APPLICATION FOR  
AMENDMENT OF PLAN UNDER SECTION 12A OF  
THE TOWN PLANNING ORDINANCE  
(CAP.131)

6. Plan Proposed to be Amended 擬議修訂的圖則	
(a) Name and number of the related statutory plan(s) 有關法定圖則的名稱及編號	Draft Kwai Chung Outline Zoning Plan No. S/KC/31
(b) Land use zone(s) involved (if applicable) 涉及的土地用途地帶(如適用)	"Other Specified Uses" annotated "Container Terminal"

This Planning Application is prepared and submitted on behalf of Omaha Investments Limited (the “Applicant”) to seek approval from the Town Planning Board (“TPB”/the “Board”) under section 12A of the Town Planning Ordinance for the rezoning of Hutchison Logistics Centre (“HLC”) from “Other Specified Uses” annotated “Container Terminal” (“OU(CT)”) Zone and to “Other Specified Uses” annotated “Container Terminal (1)” (“OU(CT)1”) Zone in the Approved Kwai Chung Outline Zoning Plan (“OZP”) No. S/KC/30, to enable the proposed data centre development at 6/F of HLC at 18 Container Port Road South, Kwai Chung (“Application Site”/ “the Site”).

Figure 3-1	Application Site Location, Assessment Area and Noise Sensitive Receiver
------------	---

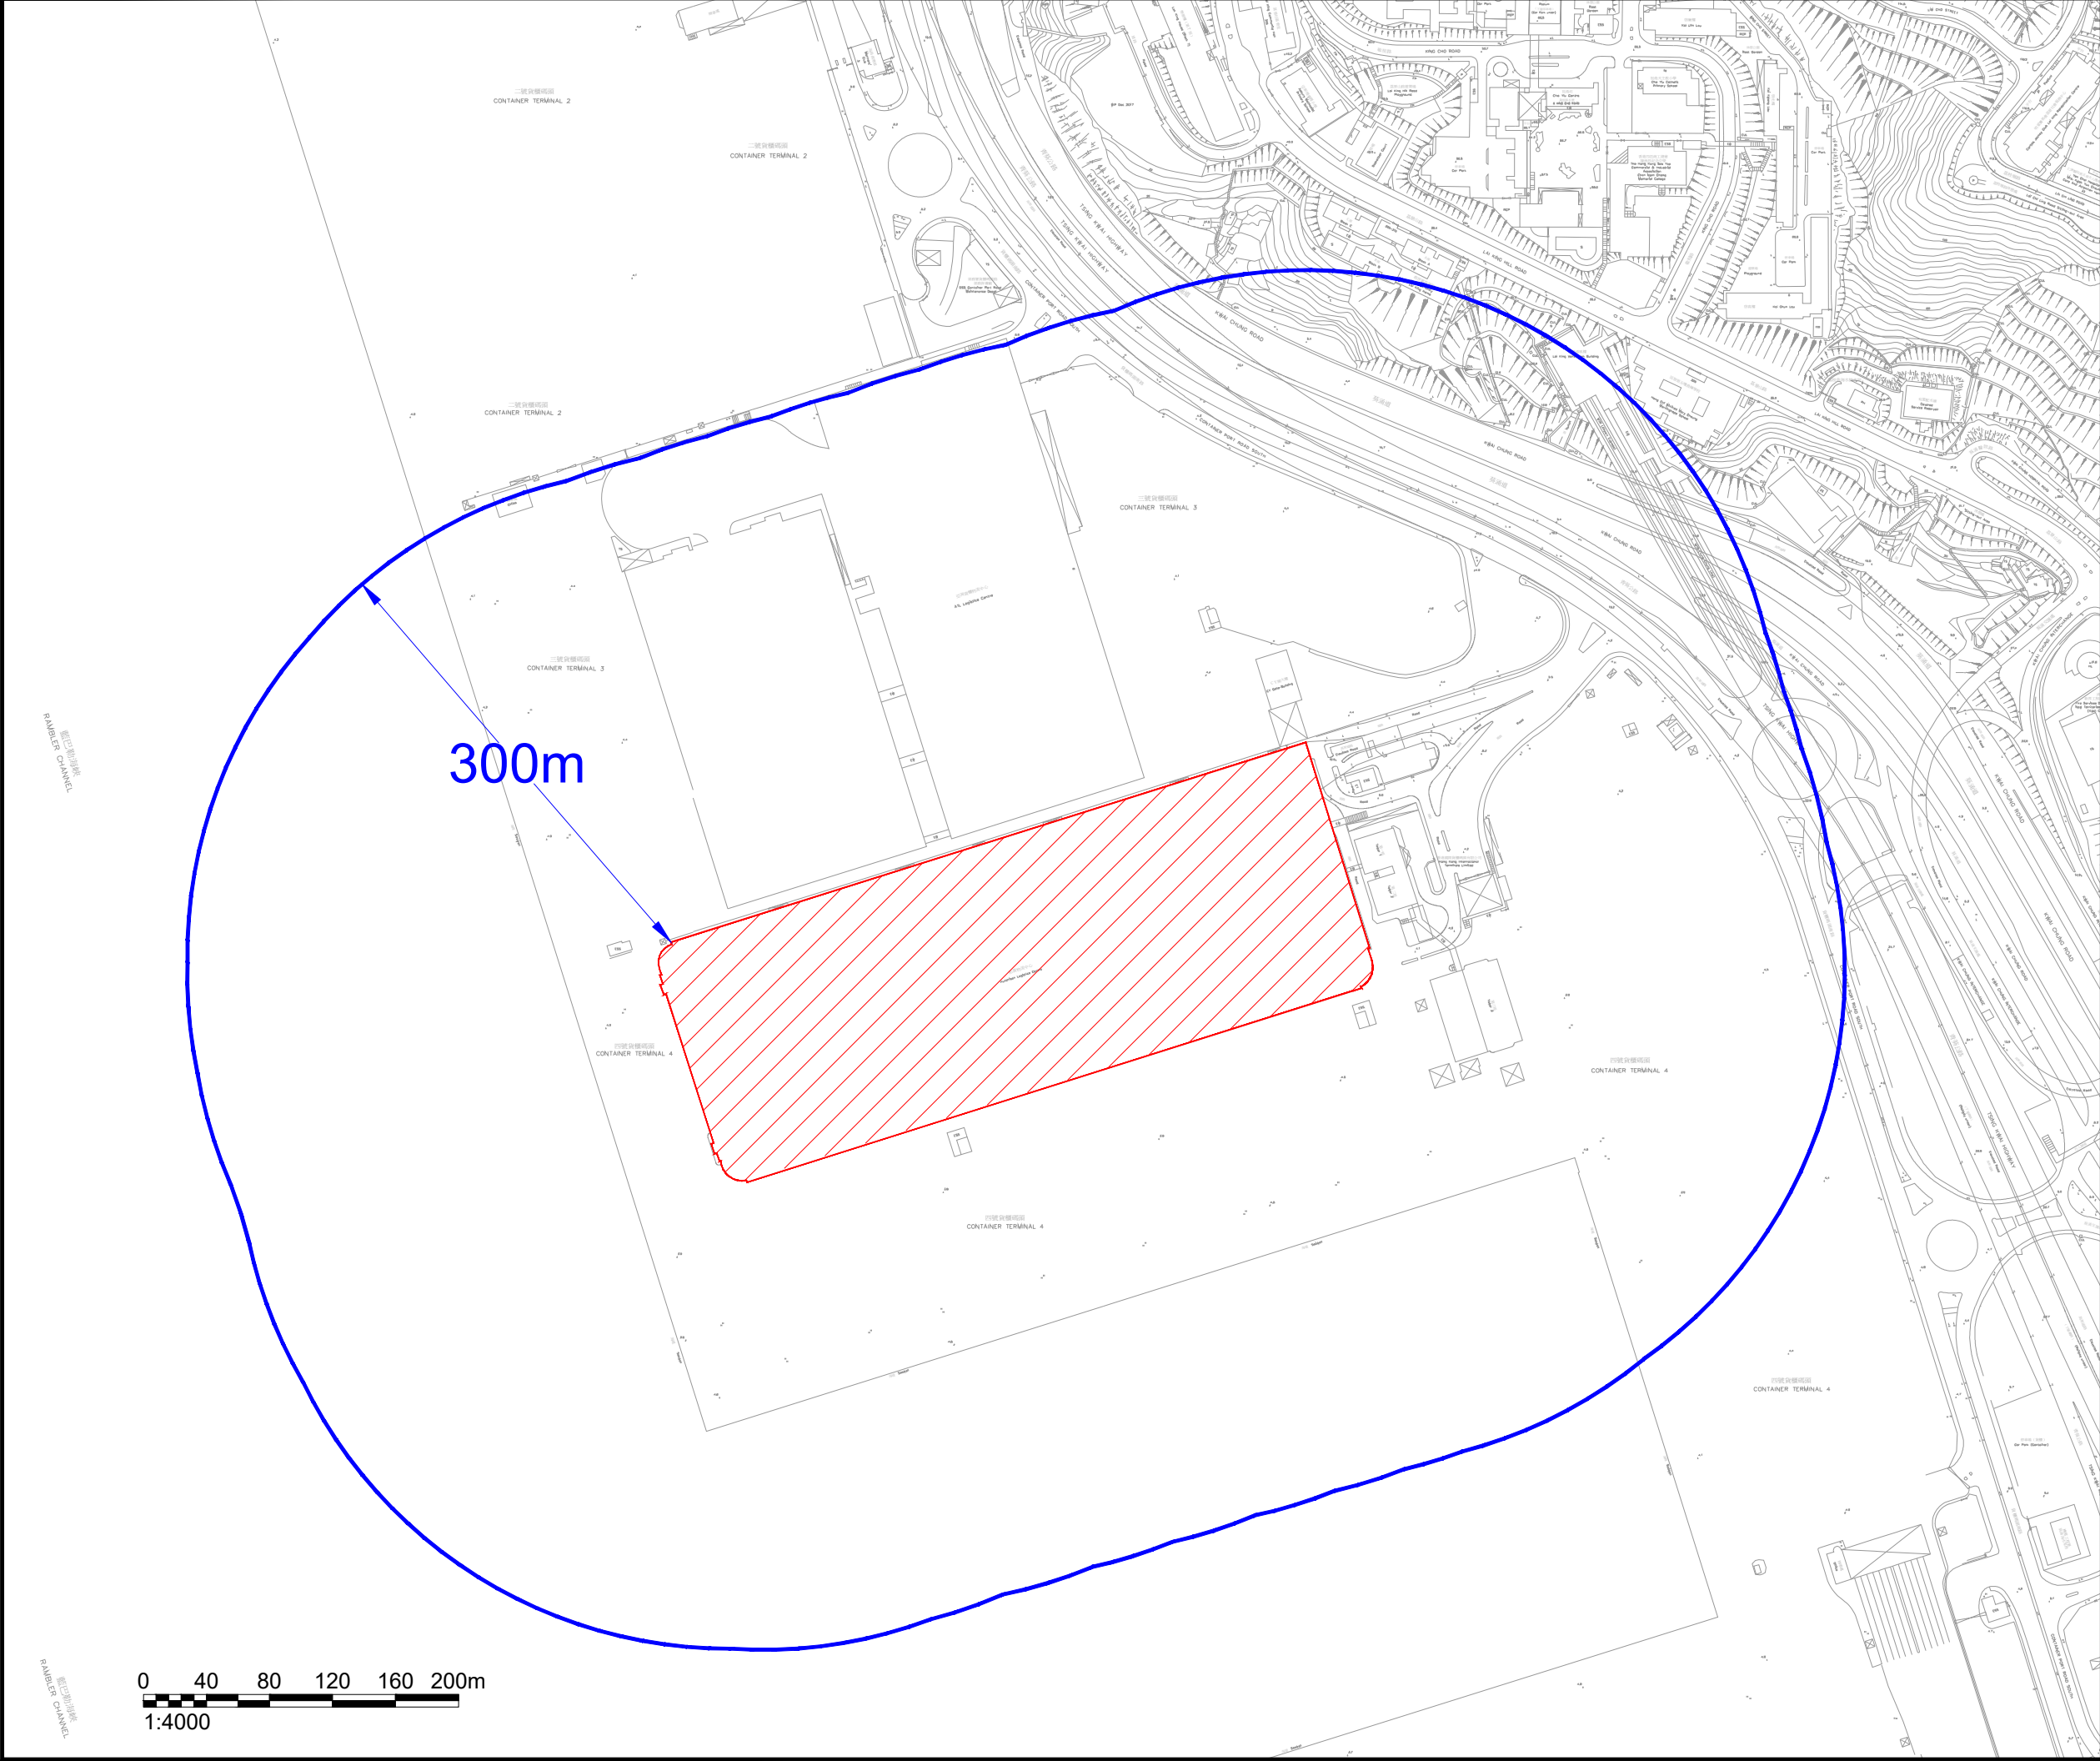
3. Section 6.1.4 -There are two NSRs (e.g. The Salvation Army Lai King Home, Hong Chi Winifred Mary Cheung Morninghope school) situated to the northeast of the Application Site, please revise the paragraph and supplement with a NSR figure.	It is noted that Hong Chi Winifred Mary Cheung Morninghope School is located outside the 300m assessment area. The paragraph and the NSR have been incorporated in the <b>Figure 3-1</b> of the revised NIA enclosed in <b>Annex B</b> . Please refer to <b>Section 6.1.8</b> and <b>Figure 3-1</b> , which have been amended accordingly as follows:  <i>"With reference to <b>Figure 3-1</b>, one NSR, namely The Salvation Army Lai King Home is identified in the 300m noise assessment area for the Proposed Development."</i>

- 6.1.7. The planned fixed plant noise sources at the Proposed Development will include the air cool chillers and the building services equipment at the roof floor.
- 6.1.8. With reference to **Figure 3-1**, one NSR, namely The Salvation Army Lai King Home is identified in the 300m noise assessment area for the Proposed Development.
